Date: October 7, 2020
To: West Linn Planning Commission
From: Jennifer Arnold, Associate Planner
Subject: Written Testimony: SUB-20-01 – 6-Lot Subdivision at 4096 Cornwall Street

Public Testimony: Willow Ridge Geologic and Hydrologic Risk Parameters

Willow Ridge Proposed Development 4096 Cornwall St., West Linn, OR Tax Lot: 6300

Exhibit 1

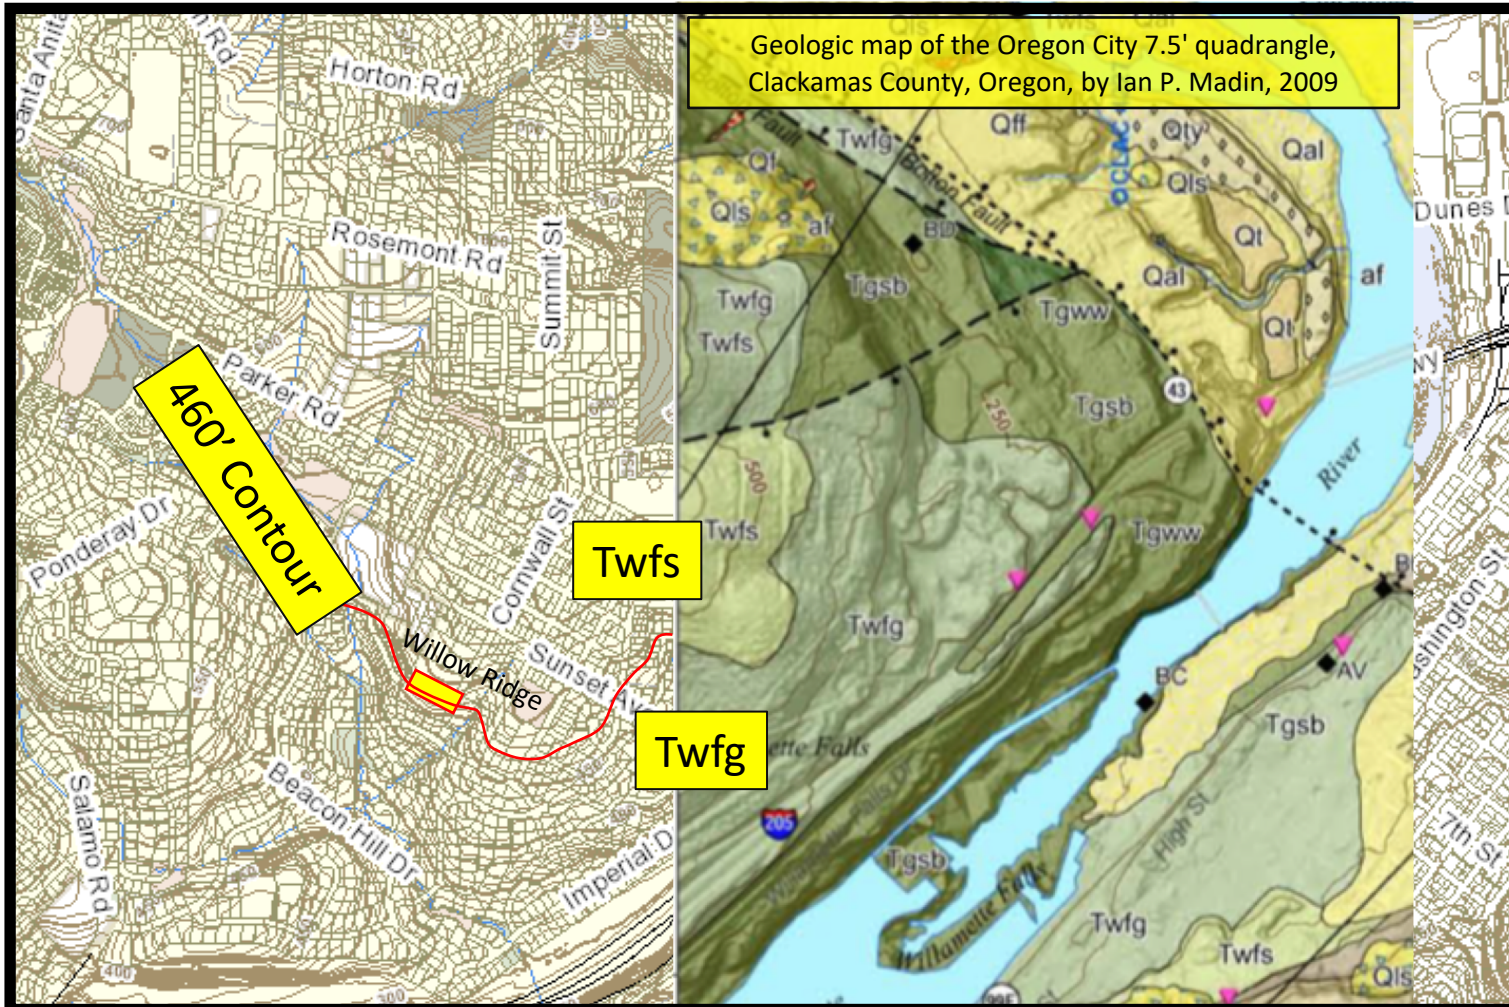
The Frenchman Springs member is divided into the upper Sandy Hollow Unit (Twfs) and the lower Gingko Unit (Twfg) (Exhibit 1a). The contact between this units occurs at 460' ASL on the western edge of the Oregon City Quadrangle geological map. The tabular nature of these units allows a reasonable interpretation that the contact will be at the same level 1,570 feet to the west of the geologic map in the Willow Ridge development (Exhibit 1).

Maps showing the extension of the contact between the Sandy Hollow and Gingko units of the Frenchman Springs member of the Wanapum Basalts

Exhibit 5

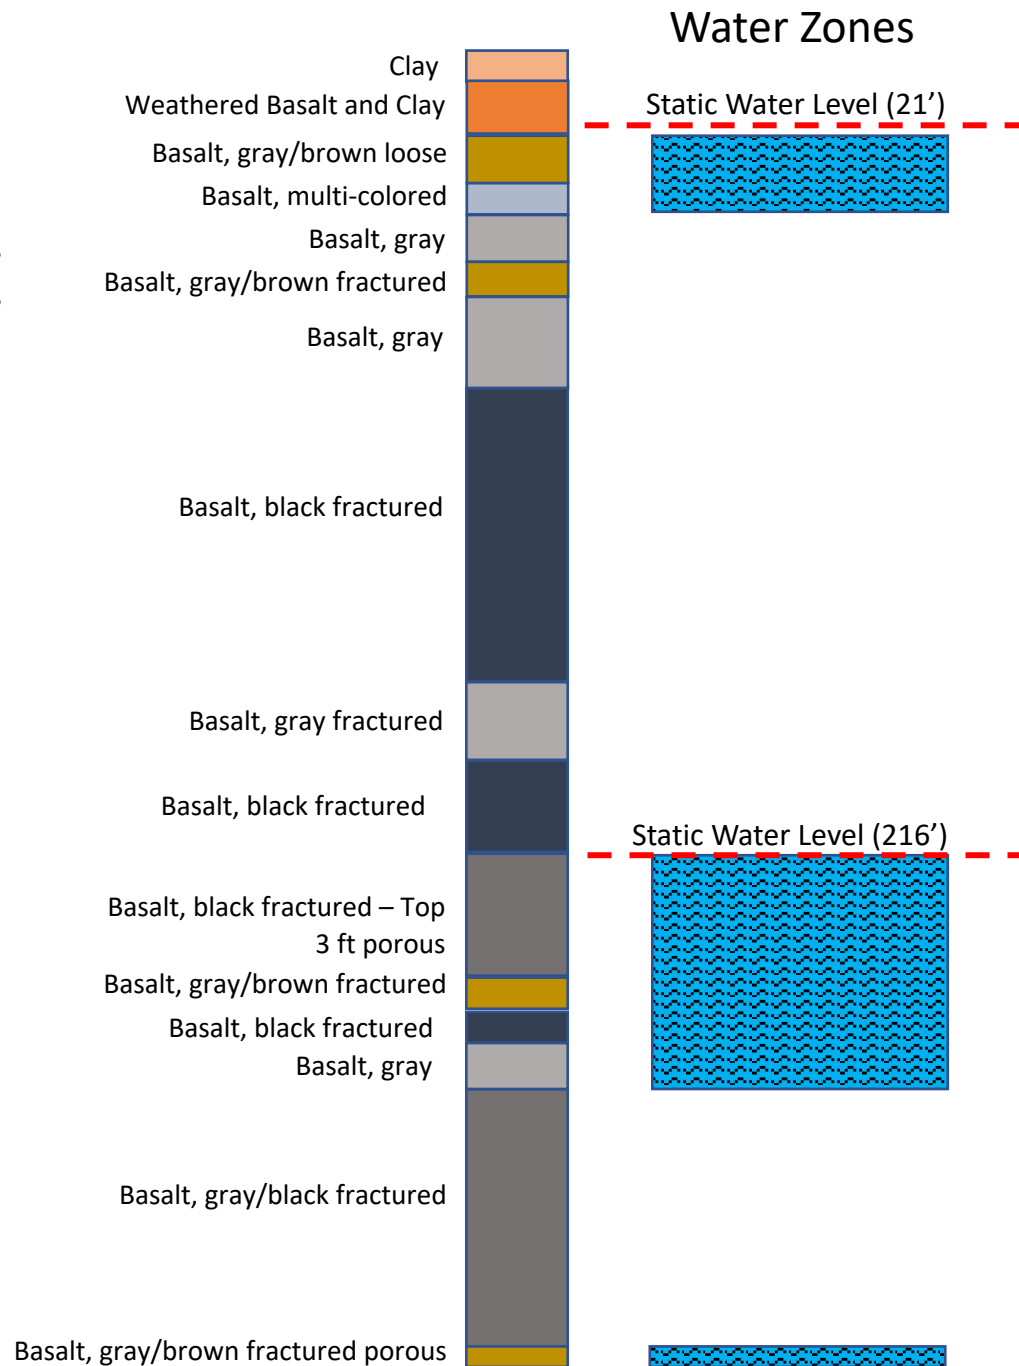
The base of the water-bearing zone is 462 feet ASL. This correspond closely with the projected geological contact between the upper and lower Frenchman Springs units. Below this contact gray basalts followed by gray/brown fractured basalts were encountered. The next water zone in the well was encountered between 216 – 280 feet ASL.

Perched water was encountered in this well with a floor at 46 feet below ground level or an elevation of 462 feet asl

Exhibit 6

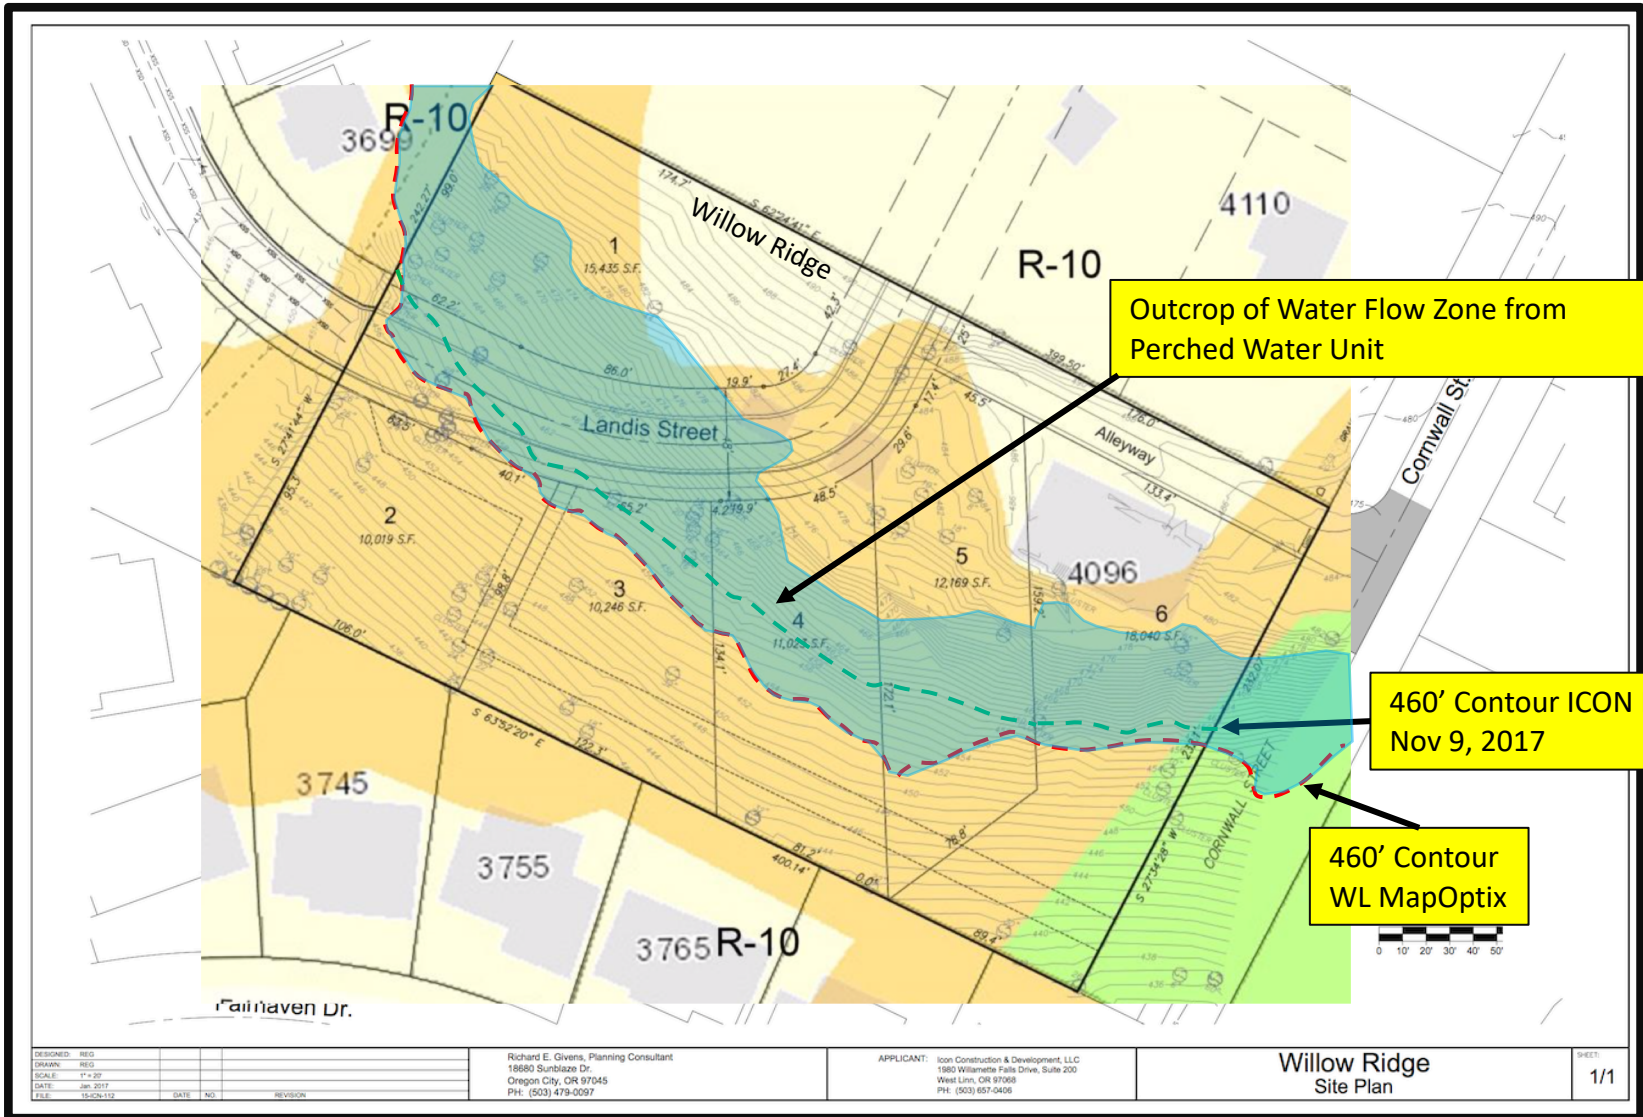
The steep slopes of the Willow Ridge Development represent an area where the topography cuts through the Frenchman Springs basalts and exposes the perched water unit to the surface. The water zone cuts across the development area in a generally NW-SE line, following the topography between 460 – 480 feet asl (Exhibit 6).

The water zone map in Exhibit 6 was constructed using the MapOptix contours. The exhibit denotes differences between the MapOptix 460 foot contour and the ICON maps used in their original planning application.

Estimated Water Flow Zone based on the Reed Street Well (Uses terrain contours from MapOptix)

Reasons for differences between the ICON map contours and the MapOptix terrain contours are unknown

Geologic Cross Section (Profile)

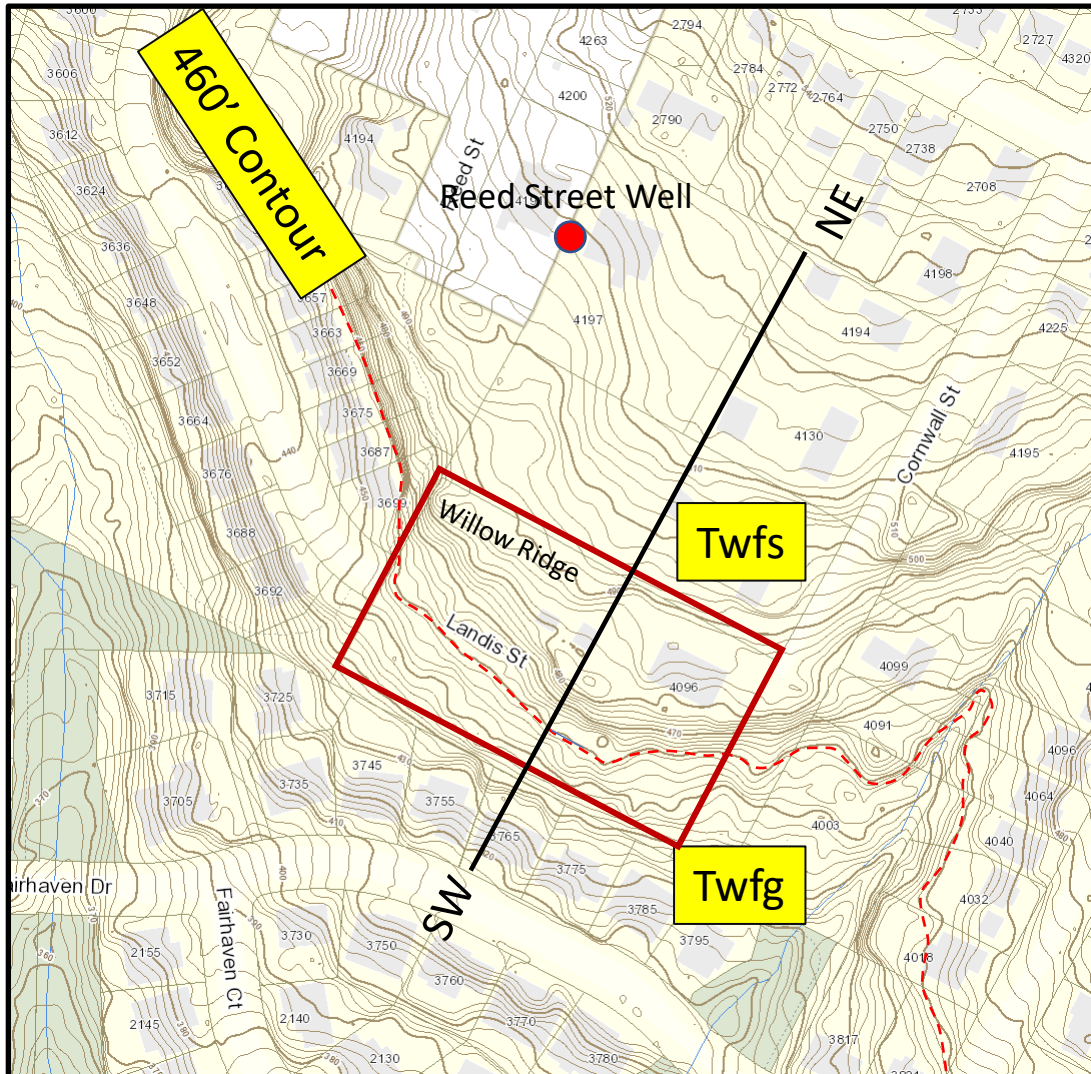
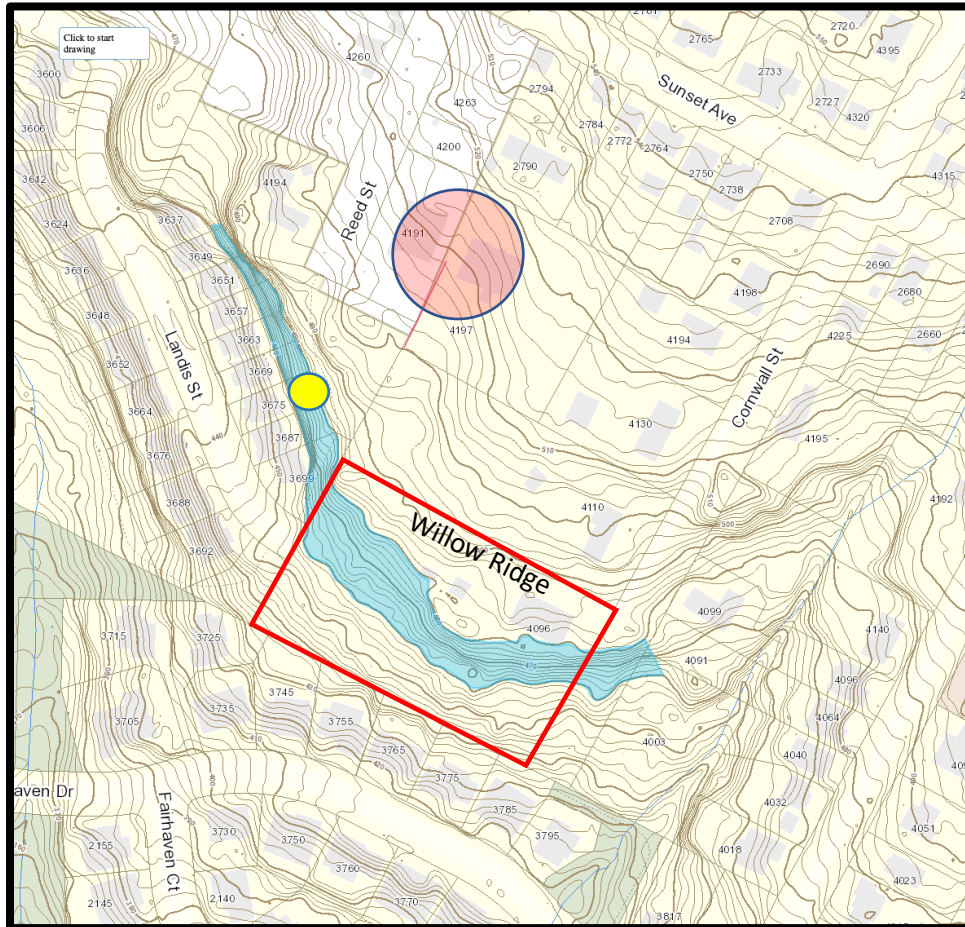
A cross sectional representation of the local geology and the perched water zone is shown in Exhibits 7 & 7a. The diagram shows the natural water flow from the subsurface to the surface

along the Willow Ridge slope. The zone of flow corresponds to the noted presence of live springs and water loving Willow trees that occur naturally along the length of the ridge.

The dynamics of this natural water flow system are such that water enters the system via precipitation on the ground surfaces above the 460 foot contour. The water migrates vertically into the soils until it reaches the top of the gray basalt layer at about 460 feet ASL. This layer forms a permeability barrier and the water accumulates as a perched aquifer. The free surface along the Willow Ridge slope provides an exit point for the water and allows the aquifer to drain (Exhibit 7).

The Reed Street Well is projected into the cross section based on a ground surface elevation of 508' ASL

Public Testimony Dec. 2017:

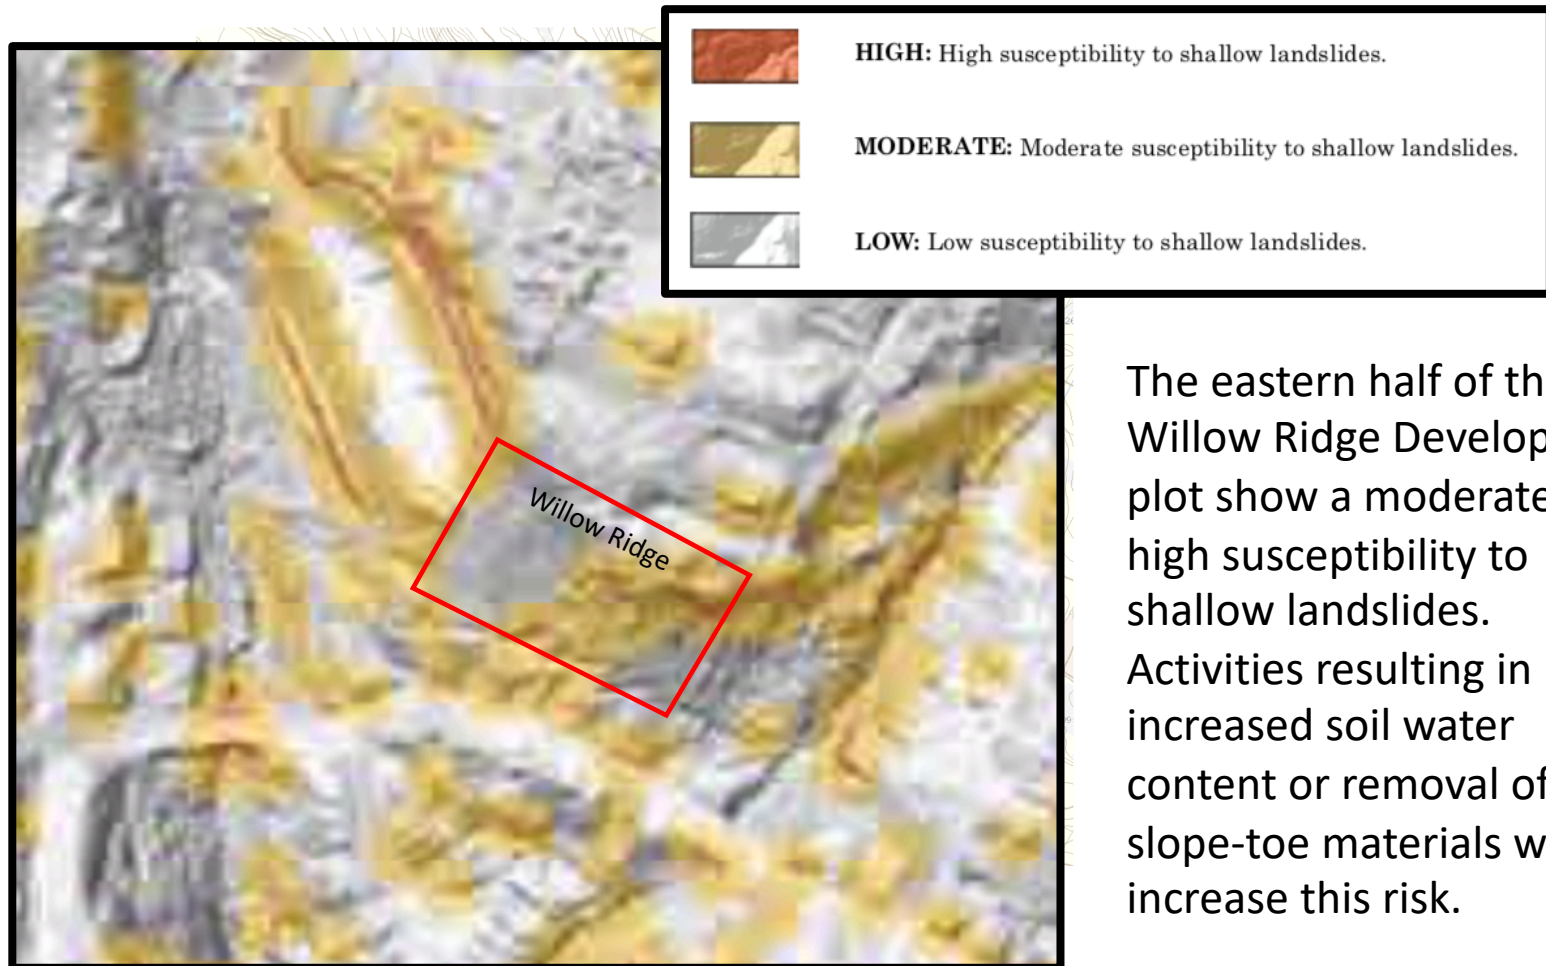
Public testimony in 2017 by Chelsea Diaz demonstrated a clear connection between upslope changes in drainage cause by construction and the subsequent increased water flow from the same geological formations that occupy the Willow Ridge Development slopes. The location of this incident was immediately to the NW of the Willow Ridge plot in the Stonegate community. The perched water table outcrops behind the Diaz home, and flooding problems from that zone coincided with upslope construction (Exhibit 8).

“After two homes behind and above us began construction located at 4191 Reed Street and 4197 Reed Street, I noticed water streaming between the boulders in my 25 foot retaining wall into my back yard. I then began an lengthy process of trying to find where the water was coming from. After a landscape developer investigated the issue, he determined that a new spring had formed in the upper tier of my back yard.”

This demonstrates the clear connection between construction and changes in drainage above the slope and increased water flow through the “water flow zone” marked in blue.
